**International  
Aero Engines**

# SERVICE BULLETIN

NACELLE - EXHAUST - BLOCKER DOOR BUSHING/BUSHING RETAINER PIN  
INSTALLATION - MODIFICATION OF

V2500-NAC-78-0137

Blocker Door Bushing and Anti-Rotation Pin Installation Modification  
Figure 1 (Sheet 1)

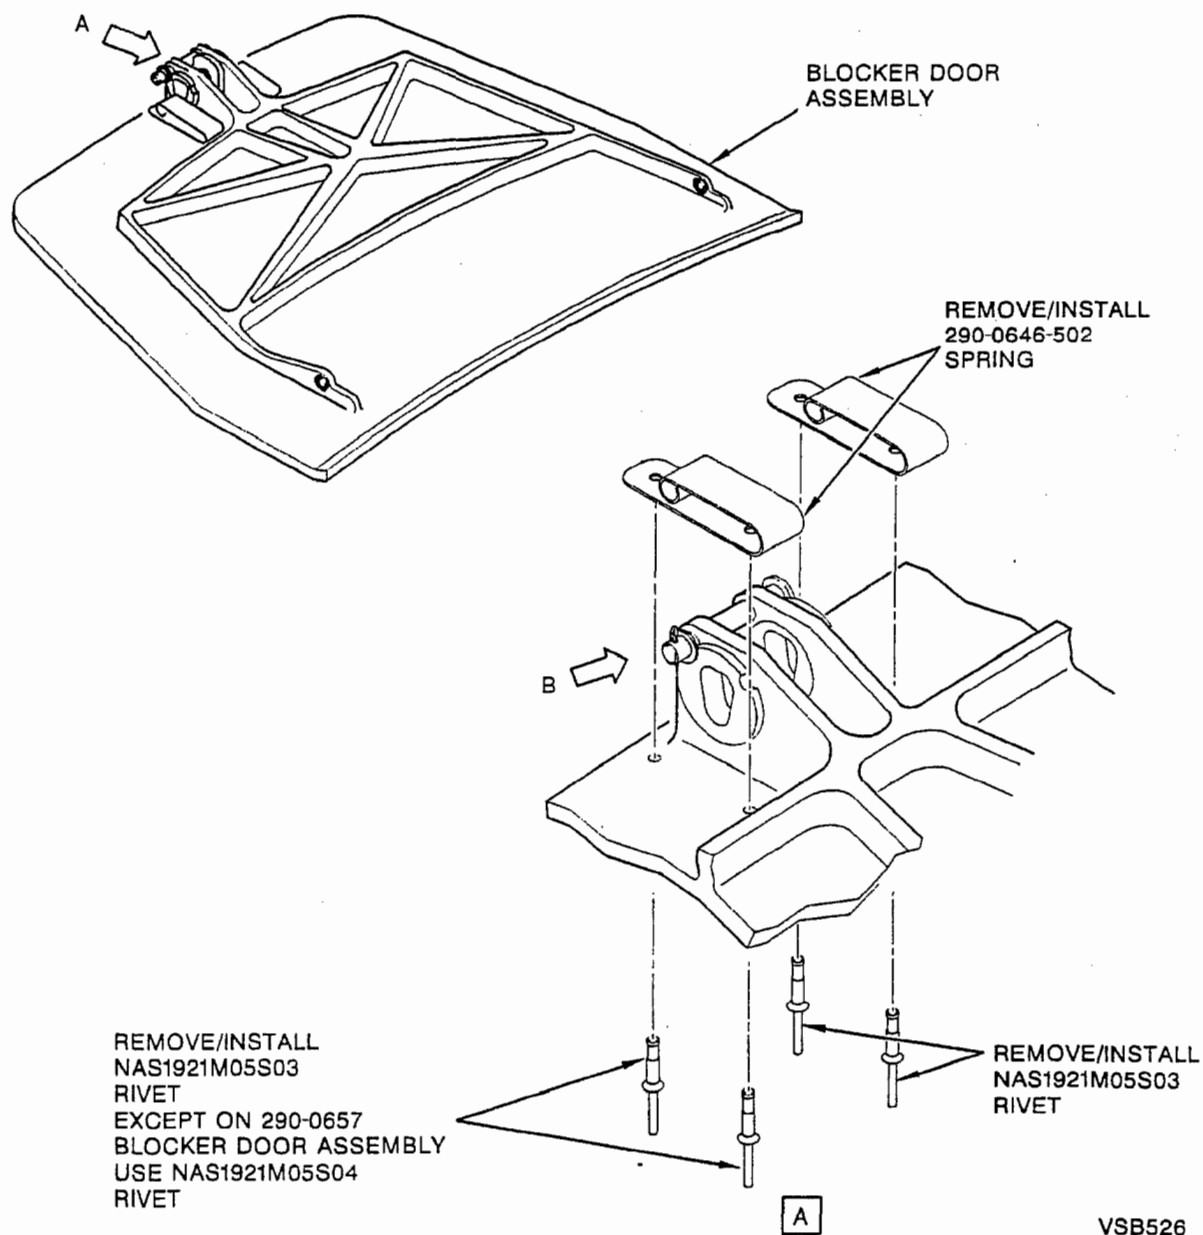
### B. Rework or Modification Instructions. Refer to Figure 1.

- (1) Remove the anti-rotation pin from the blocker door.
- (2) Drill out the rivets that attach the spring to the blocker door and remove the spring. Do not make the rivet holes larger.

- (3) Carefully remove the bushings from the blocker door. If the bushings are not loose, heat the bushings to 300 deg F with a heat gun and then remove the bushings.

- (7) Apply adhesive (CoMat 08-121) to the mating surfaces of the bushings.
- (8) Install the bushings in the blocker door.

- (9) Mix the primer base (CoMat 08-093), primer converter (CoMat 07-115), and thinner (CoMat 07-116). Refer to the manufacturer's instructions.
- (10) Install the spring on the blocker door with the rivets. Wet install the rivets with the primer mix. Wipe off any unwanted primer with a lint free cloth (CoMat 02-099) and cleaning solvent (Comat 01-438).
- (11) Install the anti-rotation pin in the blocker door.

- (12) Apply sealant (CoMat 08-030) to each end of the anti-rotation pin to keep the pin from vibrating.

Blocker Door Bushing and Anti-Rotation Pin Installation Modification  
Figure 1 (Sheet 2)

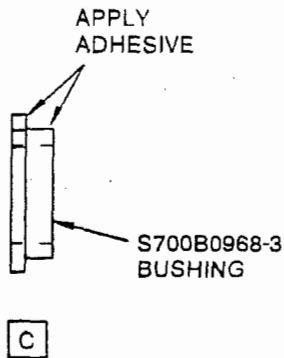
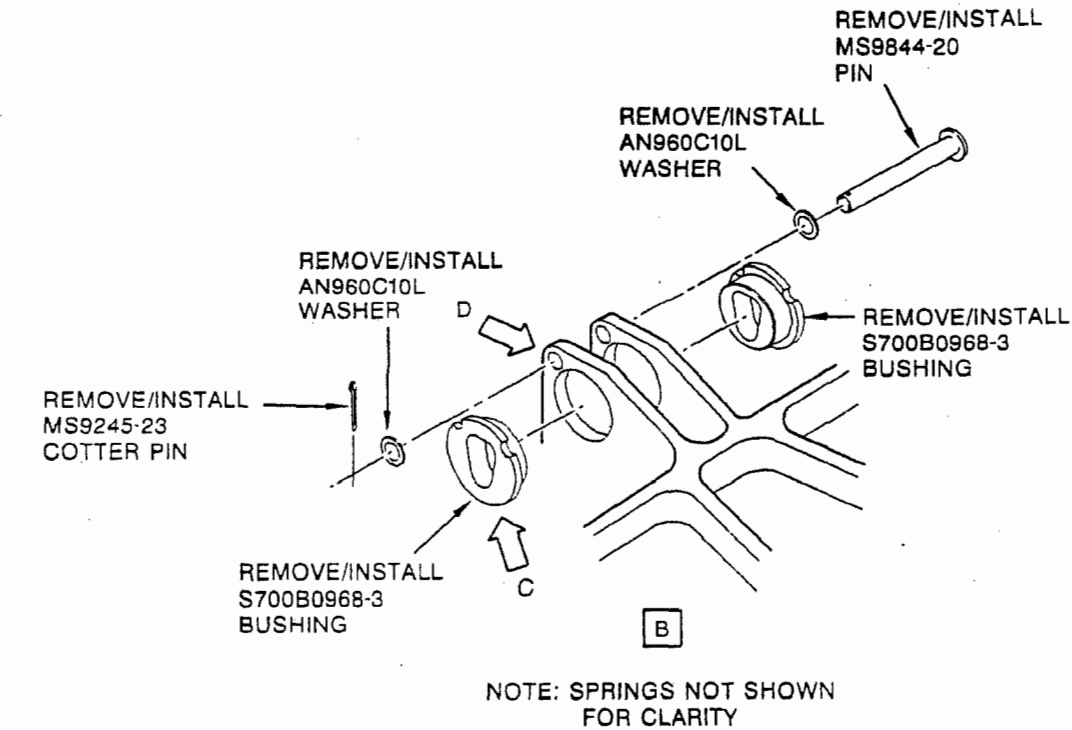
- (a) If the blocker door bushing and anti-rotation pin holes are worn/damaged more than the limits in Figure 1 (Sheet 2), Detail D, you must replace the blocker door.
